Subject: Virgil C. Summer Nuclear Station (VCSNS) Units 2 and 3 Combined License Application (COLA) - Docket Numbers 52-027 and 52-028 Response to NRC Request for Additional Information (RAI) Letter No. 031

Reference: Letter from Ravindra G. Joshi (NRC) to Alfred M. Paglia (SCE&G), Request for Additional Information Letter No. 031 Related to SRP Section 2.5.4 for the Virgil C. Summer Nuclear Station Units 2 and 3 Combined License Application, dated February 10, 2009.

SRP Section: 2.5.4 – Stability of Subsurface Materials and Foundations

Figure 02.05.04-2-1

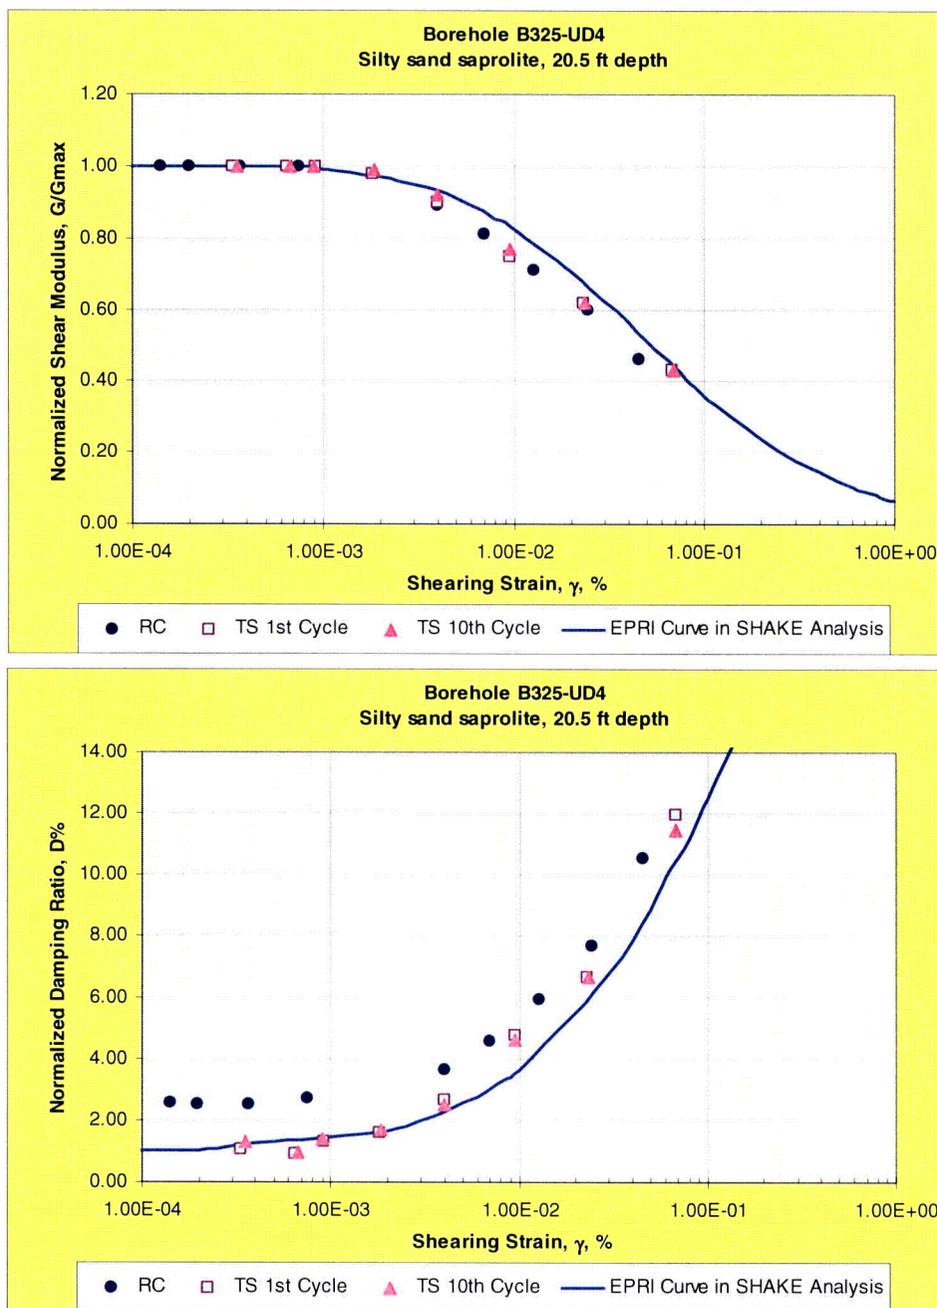
FSAR Subsection 2.5.4.2.5.4 (pg 2.5.4-13 and Figure 2.5.4-218) presents the results of 3 RCTS tests, one for saprolite and 2 for proposed fill materials. Regulatory Guide 1.138 states that a sufficient number of tests should be performed to cover the range of values expected under field conditions for the material properties being assessed. However, variations in test results due to differences in materials being tested or to scatter resulting from testing techniques may not be apparent with this small number of tests. Also, the number of tests may not be sufficient for evaluating the validity of the test results.

In order for the staff to evaluate the comparison of RCTS results with the generic curves used in the seismic soil column analyses, shown in FSAR Figure 2.5.4-218, please justify the use of the generic curves based on such sparse site-specific data and explain the apparent divergence between test results and certain of the curves.

The results of the two RCTS tests on in-situ saprolite not included in the VCSNS FSAR are included here as Figure 02.05.04-2-1 (sample UD4 from boring B-325) and Figure 02.05.04-2-2 (sample UD3 from boring B-208). The results from the two saprolite samples consisting mainly of silty sand (sample UD2 from boring B-309 [Figure 2.5.4-240a] and sample UD4 from boring B-325 [Figure 02.05.04-2-1]) are similar and the generic EPRI sand curve used for G/G_{max} versus shear strain in the SHAKE analysis is close to a best fit curve for the RCTS G/G_{max} results for both samples. The generic EPRI sand D versus shear strain curves agrees well with the torsional shear RCTS results for both samples. The torsional shear results are lower (more conservative) than the resonant column results at lower strains.

The results of the additional 2 RCTS tests (shown in Figures 02.05.04-2-1 and 02.05.04-2-2 will be included in a future revision of the COLA.

Figure 02.05.04-10-1

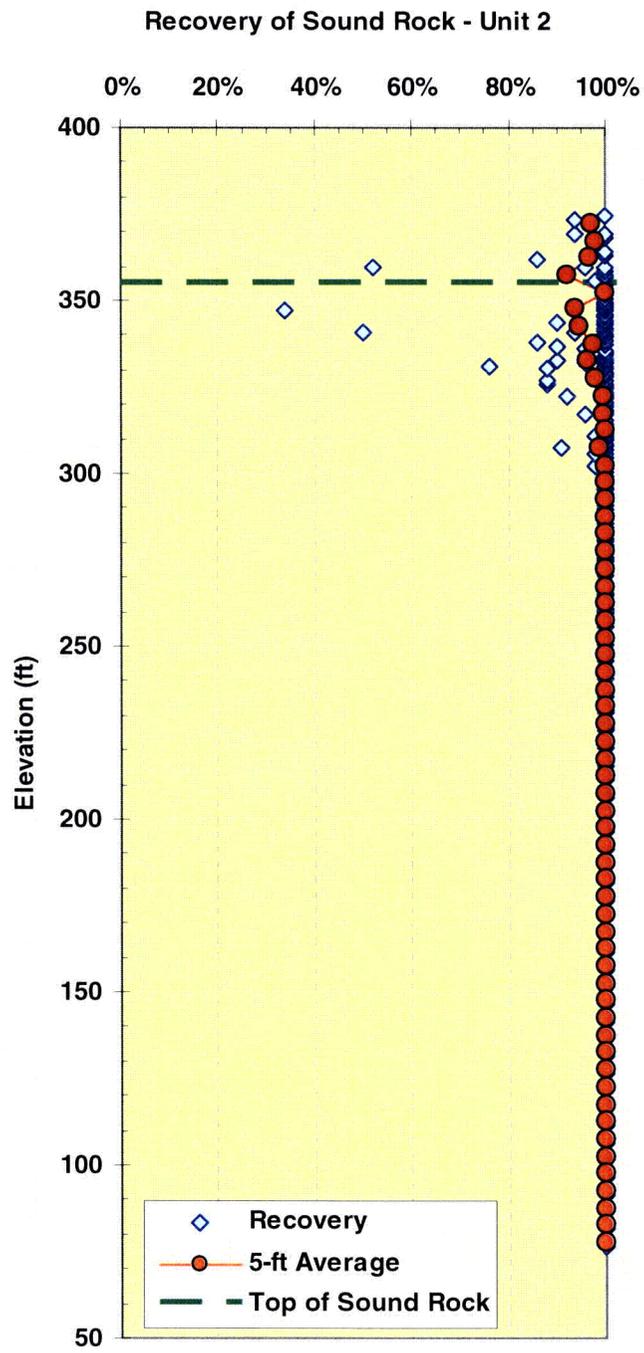
FSAR Figure 2.5.4-224 shows that the shear wave velocity is variable across the power block area (PBA). Regulatory Guide 1.132 states that, where variable conditions are found, spacing of boreholes should be smaller, as needed, to obtain a clear picture of soil or rock properties and their variability.

In order for the staff to determine whether more boreholes may be needed, please provide justification for not having a smaller spacing of borings within the Unit 2 PBA and Nuclear Island (NI) footprint to better define the rock quality designation (RQD) and shear wave velocities.

FSAR Figure 2.5.4-211 shows the RQD values from 15 Unit 2 borings in the Layer V sound rock. Six of the borings are beneath the nuclear island, and the majority of the remainder are from beneath the annex and turbine buildings. The RQD values are averaged for 5 ft intervals. From El. 320 ft down to El. 75 ft, these average RQD values are all between 90% and 100%. From El. 320 ft up to the proposed base of the nuclear island at El. 360 ft, the average RQDs are between 80% and 90%. Attached are the percent recovery values for the same 15 borings (Figure 02.05.04-10-1). From El. 300 ft down to El. 75 ft, all of the recovery values are 100%. From El. 300 ft up to the proposed base of the nuclear island at El. 360 ft, the average recoveries are between 90% and 100%, with the majority over 95%. These are by no means variable conditions; therefore a closer boring spacing is not required.

FSAR Figure 2.5.4-224 shows the measured shear wave velocities in four Unit 2 boreholes. FSAR Figure 2.5.4-226 shows these data reduced to average and +/- 1 standard deviation. From El. 300 ft down to El. 90 ft, the average shear wave velocity is close to 10,000 fps, and the maximum standard deviation is less than 500 fps (coefficient of variation, COV = 0.05). From El. 300 ft to El. 325 ft, the average is closer to 9,500 fps and the maximum standard deviation is just over 1,000 fps (COV = 0.11). Between El. 325 ft and El. 355 ft, the average velocity drops to just over 8,500 fps and the maximum standard deviation is just under 2,000 fps (COV = 0.23). The increase in variability towards the rock surface is expected – although this is among some of the strongest and least fractured/weathered rock encountered in the Piedmont, some degradation towards the surface is almost inevitable (except under Unit 3 which is truly exceptional). Again, for a bedrock environment, these are by no means variable conditions; therefore a closer boring spacing is not required.
